Subject Proposed Landfarm – Kugaaruk

This is in response to your correspondence, dated May 10, 2006, to Mr. Navjit Sidhu regarding the review of the Water Licence Application submitted by Wardrop Engineering for a soil treatment landfarm near the Hamlet of Kugaaruk. Mr. Sidhu has directed Wardrop to provide responses to the issues raised in your letter.

LANDFARM WATER HANDLING FACILITIES
KUGAARUK, NUNAVUT
OVERALL SITE PLAN & DETAILS

DESIGNED BY: LS	DRAWN BY: SR	DWG NO.
CHECKED BY:	DATE: 06.05.31	0222880801-SKT-M0001-A

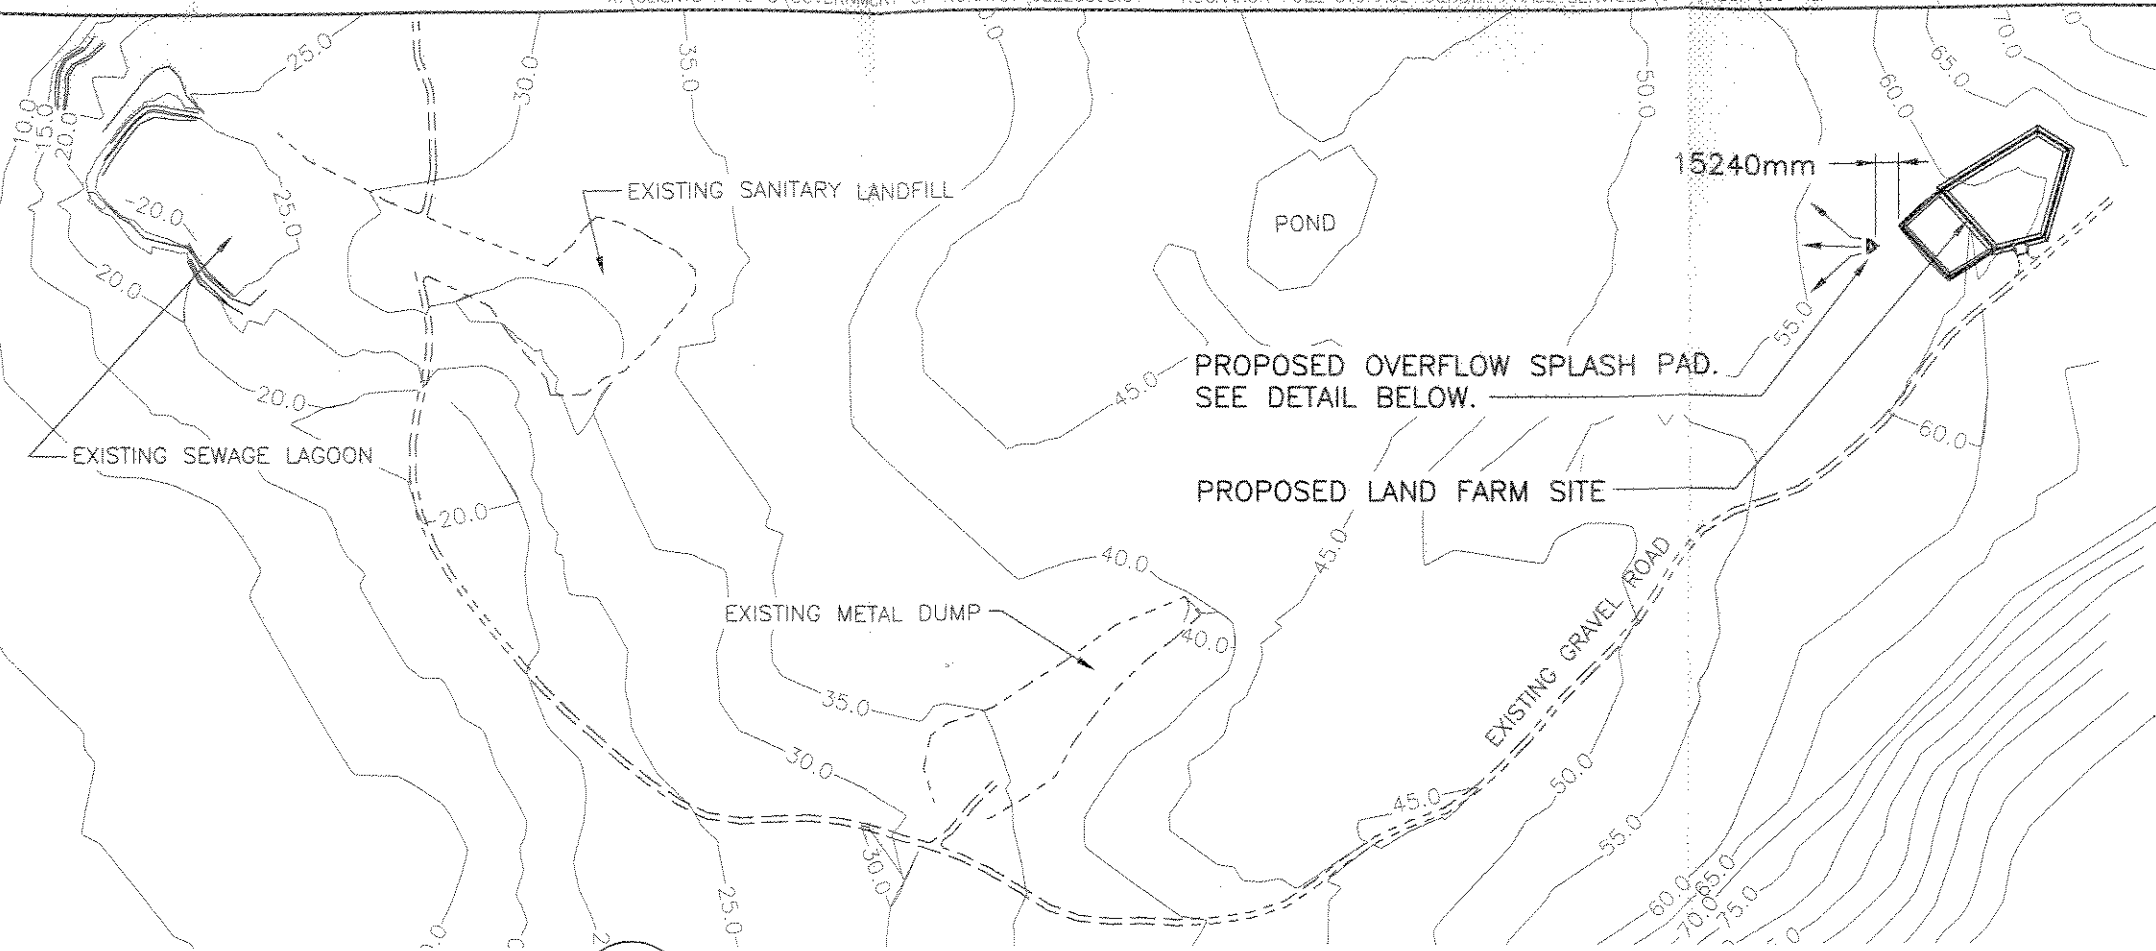
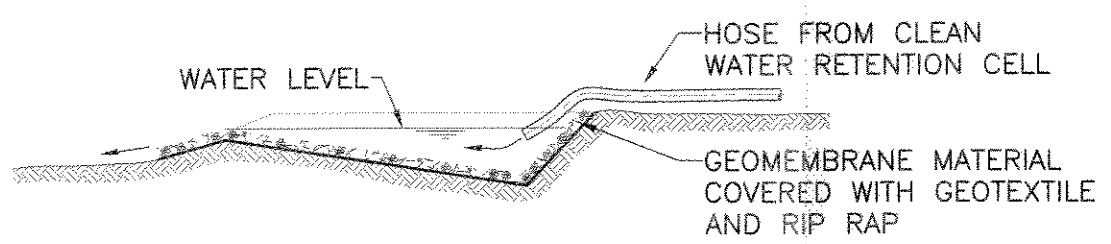
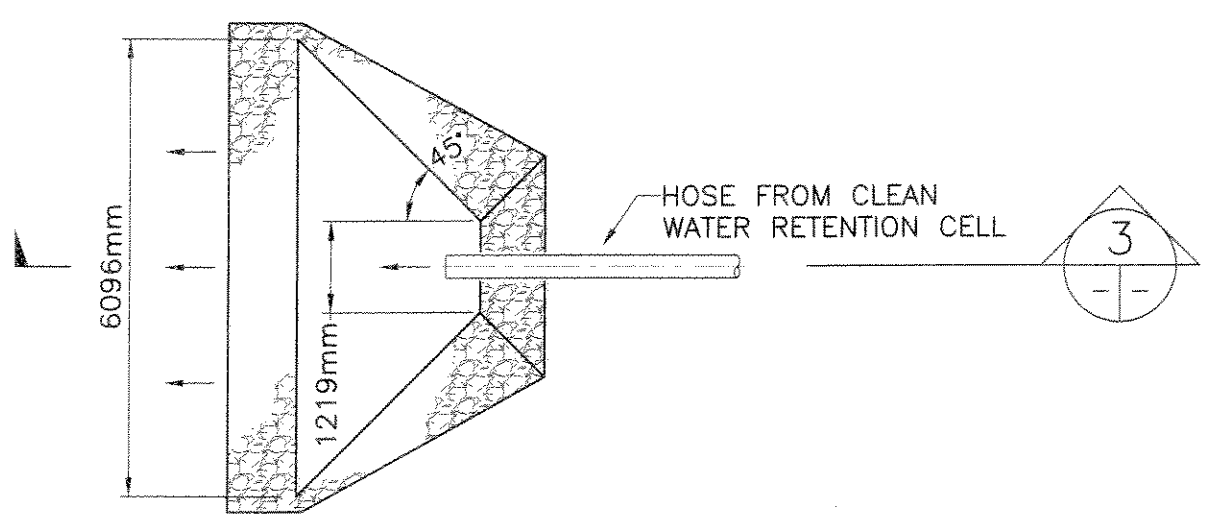
1. Splash Pad and Discharge Route

The most likely location for the splash pad will be to the west of the retention cell. The design of the pad and an approximated dispersal path from that point is illustrated on sketch SKT-M0001-A (attached).

The exact location of the splash pad will be determined in the field since topographic drawings do not necessarily reveal the required level of local detail. The intent will be to use a location where downstream flow can dissipate over a relatively broad area via existing natural drainage contours, instead of promoting channelized flow.

The splash pad will be constructed of two layers of nonwoven geotextile covering an area of approximately 50 m². The geotextile will be covered with riprap to a depth of 250 mm. Riprap will consist of local rock sized from 20 to 150 mm. The base will be cleared of debris and compacted with local equipment before placement of the geotextile. The configuration of the pad will broaden toward the downstream end to promote wider distribution of the discharge. During discharge periods, the line from the pump will be fixed at the upstream side of the splash pad. The discharge will be visually monitored on a frequent basis. The location of the discharge line will be adjusted as necessary to optimize the flow conditions over the pad and the riprap blanket will be repaired as necessary by adjusting the configuration of the stone layer.
